TMS320C6201
Digital Signal Processor
Silicon Errata

SPRZ153
November 2000

Figure 2. SBSRAM Read Timing (1/2 Rate SSCLK) (See Note)

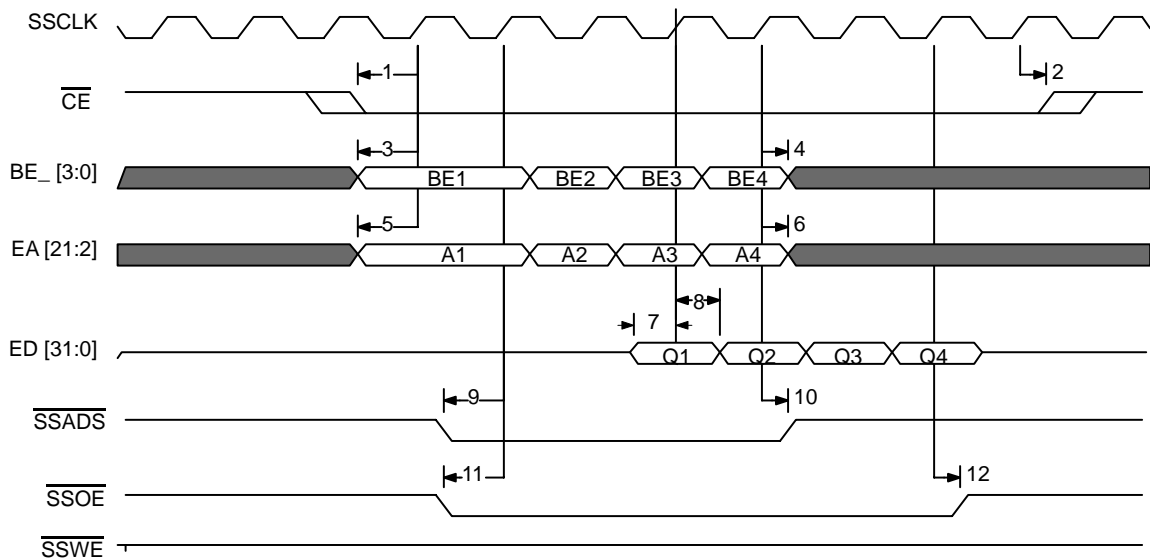
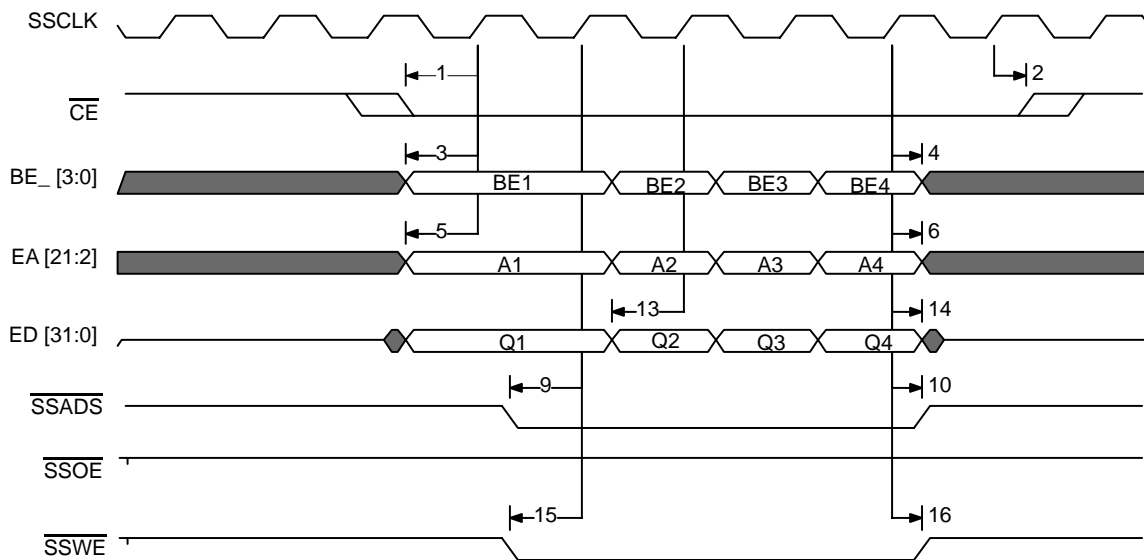
NOTE: The $\overline{\text{CE}}$ output setup and hold times are specified to be accurate relative to the clock cycle to which they are referenced, since these timings are specified as minimums. However, the $\overline{\text{CE}}$ output setup and hold time may be greater than that shown in the data sheet in multiples of P ns. In other words, for output setup time, the $\overline{\text{CE}}$ transition from high to low may happen P, 2P, ..., or nP ns before the time specified by the data sheet. Similarly, for output hold time, the $\overline{\text{CE}}$ low-to-high transition may happen P, 2P, ..., or nP ns after the time specified by the data sheet. This is indicated by the period of uncertainty for specs 1 and 2 in Figure 2, and Figure 3.

NOTE: The \overline{CE} output setup and hold times are specified to be accurate relative to the clock cycle to which they are referenced, since these timings are specified as minimums. However, the \overline{CE} output setup and hold time may be greater than that shown in the data sheet in multiples of P ns. In other words, for output setup time, the \overline{CE} transition from high to low may happen P, 2P, ..., or nP ns before the time specified by the data sheet. Similarly, for output hold time, the \overline{CE} low-to-high transition may happen P, 2P, ..., or nP ns after the time specified by the data sheet. This is indicated by the period of uncertainty for specs 1 and 2 in Figure 2, and Figure 3.

Figure 4. Write Example – Desired Behavior

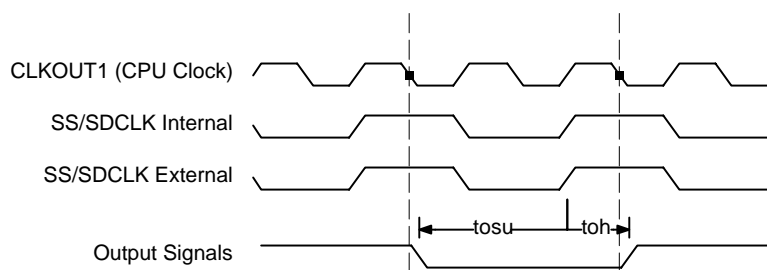
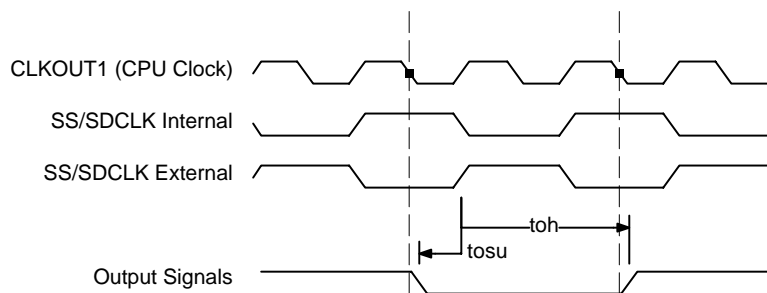
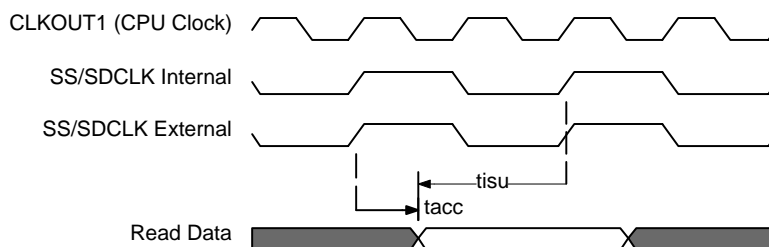
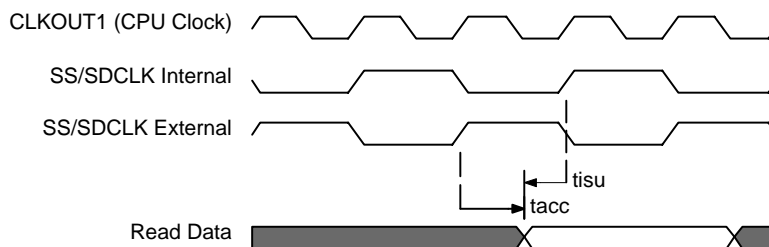
A speedpath in the device causes SDCLK and SSCLK to start up 180 degrees out-of-phase (effectively inverted) from the desired waveform. Normally, EMIF outputs are delayed 1/2 CPU clock from the rising edge of SDCLK/SSCLK to give it adequate hold time while maintaining more than adequate setup times.

The desired relationship is described in the TMS320C6201B data sheet (SPRS051) and is illustrated in Figure 4 and Figure 6. However, in the case where SDCLK/SSCLK becomes inverted (Figure 5 and Figure 7), control signals only have 1/2 CPU clock of setup to the next SDCLK/SSCLK rising rather than 3/2 CPU clock of setup. This has two negative effects to interface timing to external synchronous RAMs.

1. On writes, setup time to RAMs for control signals and write data is reduced by 1 CPU cycle.

- On SBSRAM/SDRAM reads, data will be sampled on the falling edge before the rising edge that would be expected. In this case, the input setup time for data at the C62x™ is reduced by 1 CPU cycle. Note that this case can be compounded with Case 1. The control signals could be latched one SSCLK/SDCLK cycle (2 CPU cycles) late by the memories. Thus, the setup could be reduced by up to 3 CPU cycles and be more than an entire SSCLK/SDCLK late.

CLKOUT2 is also affected by this speedpath bug and is 180 degrees out-of-phase. It behaves in the same way as SDCLK. (Internal reference number C601307)

- For prototypes, raising the core supply to 1.9 – 2.1 V corrects this problem. This is not recommended in boards shipped to customers, since the manufacturing process is not designed to be reliable outside the normal operating range. This option allows the user to verify current board designs at all valid frequency ranges.

- Reduce the operating frequency of the TMS320C6201B until SSCLK/SDCLK has the desired relationship. Typically, this occurs at 175 MHz across the range of recommended operating conditions.

- Since SSCLK and SDCLK are inverted externally relative to each other by design, these signals can be swapped on external memory interfaces to correct the problem (SSCLK to SDRAM and SDCLK to SBSRAM). This will cause invalid operation at frequencies below 175 MHz and will not work with future silicon revisions.

- Resolution**
- Revision 3.1 of silicon will correct this problem.
